Work Order ID 149079

Item ID: D4634-145 Accept ***N900040100*** Setup Start ***NS1***
Revision ID: Stop ***NS2***
Item Name: Aft, Center Ceiling Replacement Panel Assembly
Start Date: 7/13/2016 Start Qty: 1.00 ***1*** Cust Item ID:
Required Date: 7/19/2016 Req'd Qty: 1.00 ***1*** Customer:
Reference:

D4634-145 AFT, CENTER CEILING REPLACEMENT PANEL ASSY

Subject: D4634-141/-143/-145

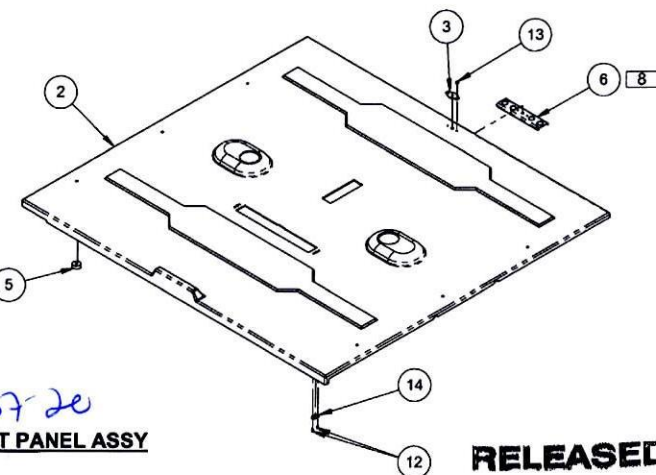
I saw the problems he was having and suggested to replace the rivets as a production tweek. I assessed the situation and suggested using an Anchor Nut Rivet (CCR264SS-3-03) when replacing the unacceptable rivet he showed me.

The installer took the initiative not to install the solid rivet in the remainder of the panels and complete the parts with CCR264SS-3-03 which turned out acceptable. (Picture 135324)

On the part which was brought to my concern there was superficial damage when he removed the rivet.

I assessed the situation and rather than scrap the panel I suggest we re-work the part to salvage it.

The fix would be to manufacture two small doublers (Picture:133104 and 133053) from 6061T6 0.020 Aluminum and dimple the top side, alodine, then sandwich the Lexan between the two doubles and bond in place, while attaching the Anchor Nut with CCR264SS-3-03.

I tried the light in place and it had no effect on the fit (picture: 133404 and 133410).

This can all be documented on the work orders as a NCR and a CAR would be generated to update the BOM to call out the CCR264SS-3-03 as an alternate to the MS20426AD3-6 rivet currently called out.

- Is it for ease installation. Are we having issues with current ones?
- Have we tried on MS20426AA rivet?
- Would we rather go with "click bond"
- Have tried the "pop" rivets – do they crack the material at edge of the hole?
- What is the cost increase per panel using the "pop" rivet.

They are assembling D4634-14X Ceiling Panels on the floor. To mount the Light, we have two nutplates riveted to the ceiling panel using MS20426AD3-4 solid rivets (eg. Sheet 7, Item 10). They are installing these nutplates using a hand bucking tool and have asked if this could be changed to a countersunk POP rivet to simplify the assembly?

It is acceptable the modification your suggested adding doublers and CCR264SS-3-03 as an alternate to the MS20426AD3-6 rivet for the product is on production to fix the issue.
